SUBJECT: Potential decreased service life of Slick 4-cylinder magneto distributor gear assemblies. **Based on process and component improvements following the initial release of this service bulletin, the serial number range is being extended in this revision. Magnetos previously returned for compliance to SB1-15 must be returned or inspected for compliance to this revision SB1-15A.**

PAGE NO.	REVISION
1 of 4	A

Figure 5. K3008 Distributor Gear With Monel Electrode

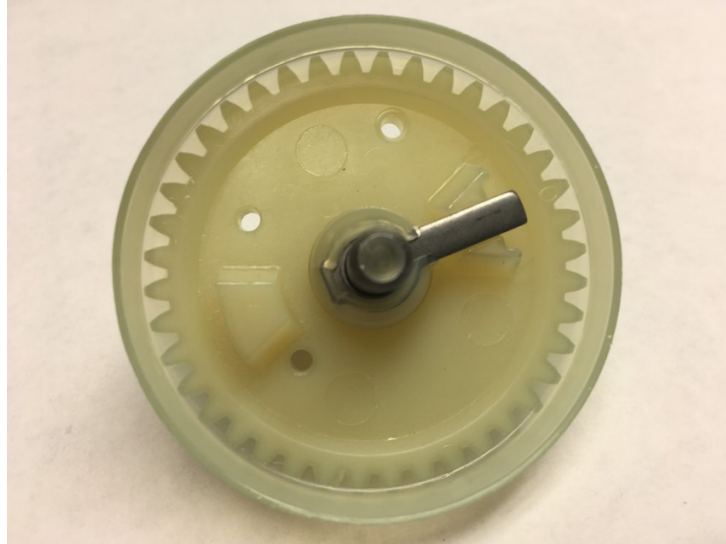
If it is not possible to confirm the version of the distributor gear that is installed in a given magneto from maintenance records, the magneto may be removed from the engine in order to have the housing and distributor block removed to allow visual inspection of the distributor gear. Distributor gears with Copper electrodes must be replaced with distributor gears with Monel electrodes.

COMPLIANCE: REMOVE affected distributor gear assembly in subject magnetos and REPLACE with replacement distributor gear assembly, K3008, as soon as possible, not to exceed the next 50 hours. Document Service Bulletin compliance as written entry in applicable Aircraft and/or Engine logbook.
